The Post Building

NMA 05 Supporting Information

This document has been prepared by Allford Hall Monaghan Morris architects as supporting information to non-material amendment 05 and is provided for illustrative purposes only.

1.1 Retail use to tenant
dedicated gym / storage space

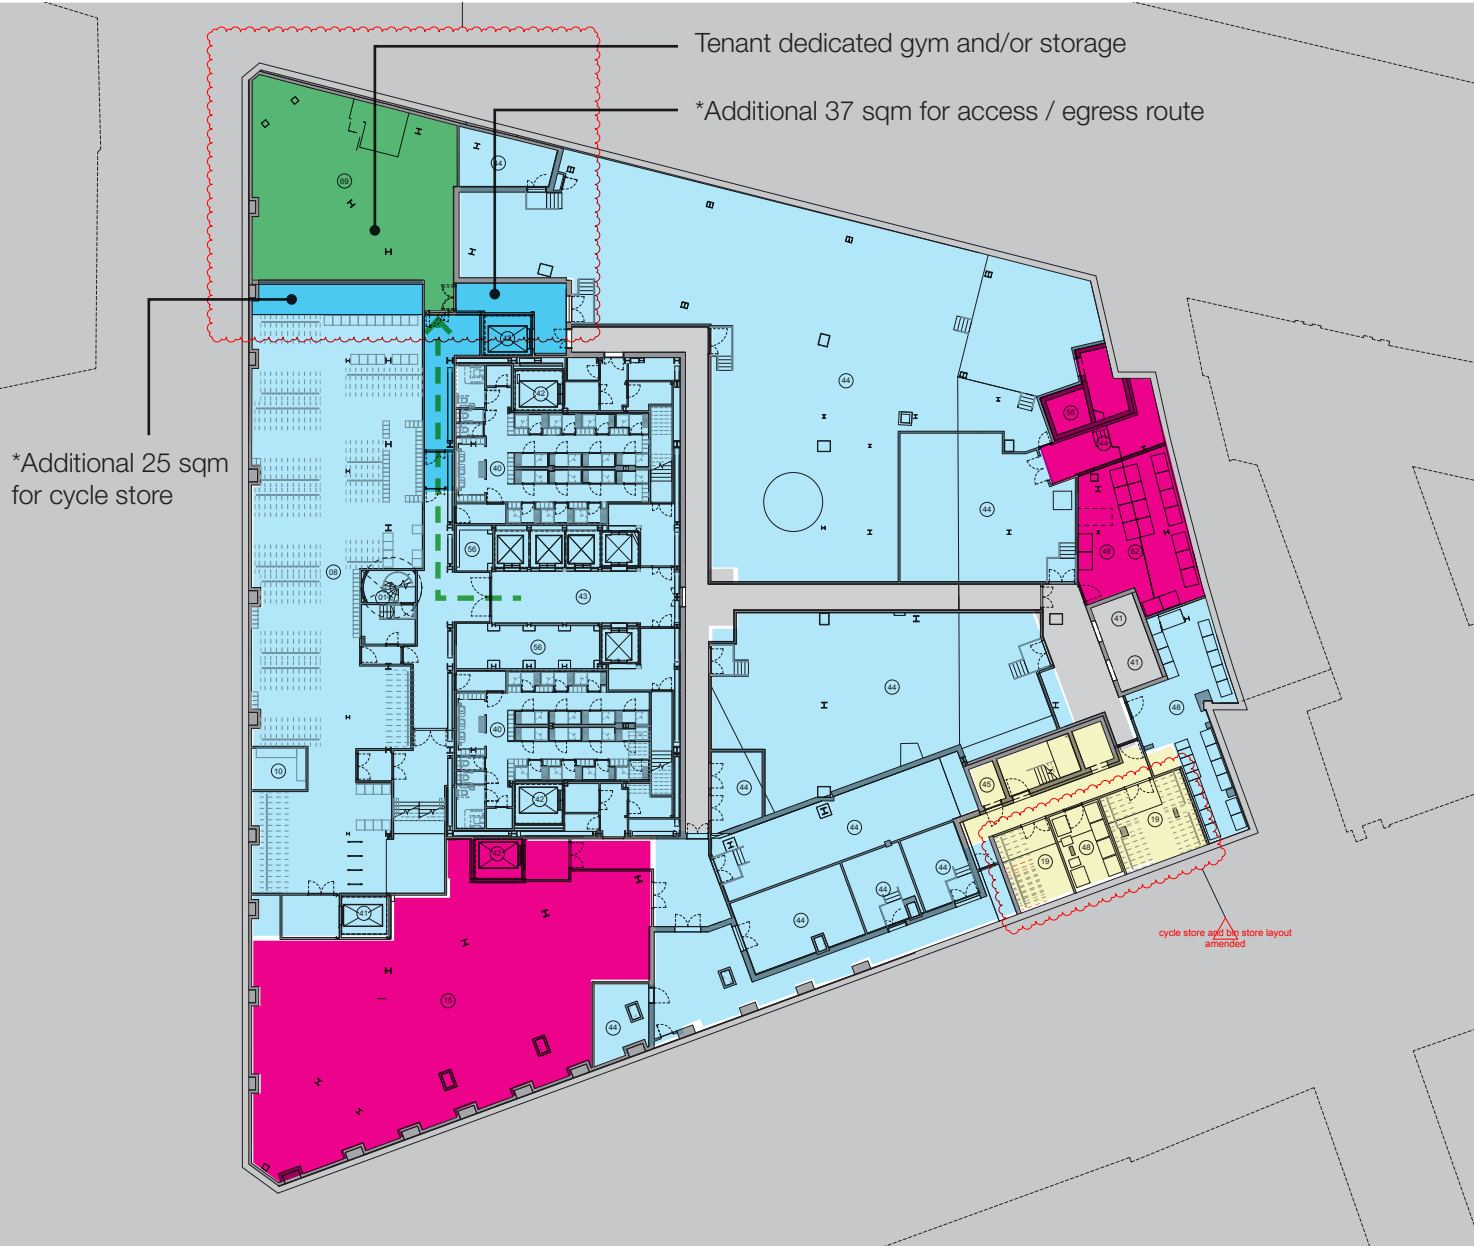
The proposed change affects the area originally designated as ancillary retail use at basement level. Whilst the ultimate use of this floorspace would be at the discretion of the retail tenant on the basis that the floorspace is located at basement level it is anticipated that this would be used as ancillary space to the units above.

As a result of the requirements of a future tenant of the office accommodation, the green highlighted area is proposed as a tenant dedicated gym and/or storage use which would be ancillary to the office (class B1) space the tenant will occupy at upper levels. Space requirements have allowed for the cycle store to increase in size, additional B1 ancillary area also forms the access / egress route from the tenant ancillary space.

<div></div>	Ancillary retail (class A1) use:	861 sqm
<div></div>	Ancillary office (class B1) use:	2,710 sqm*
<div></div>	Ancillary residential (class C3) use:	159 sqm
<div></div>	Tenant dedicated gym and/or storage - ancillary to main office (class B1) use:	201 sqm

1.2 Amended residential cycle and bin store layout

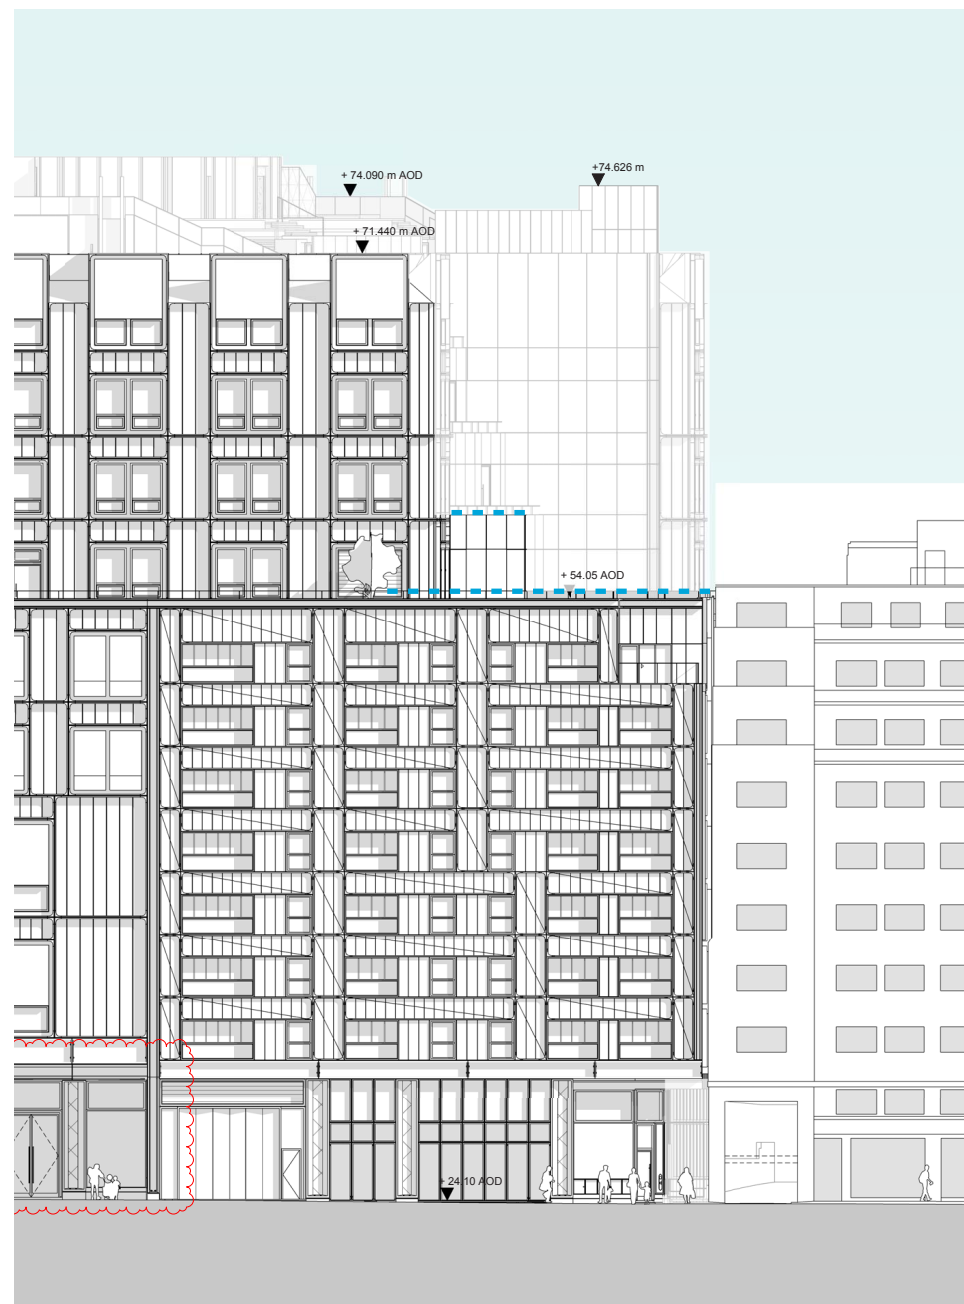
Incoming electrical cables for the sub-stations at ground level run through the centre of the previously consented residential cycle store layout. This has prevented the use of double stacked cycle racks in this area. Therefore the cycle store has been split in two with the refuse store occupying the area of reduced headroom.

Note: area and the amount of cycles remains the same as the previously consented scheme.
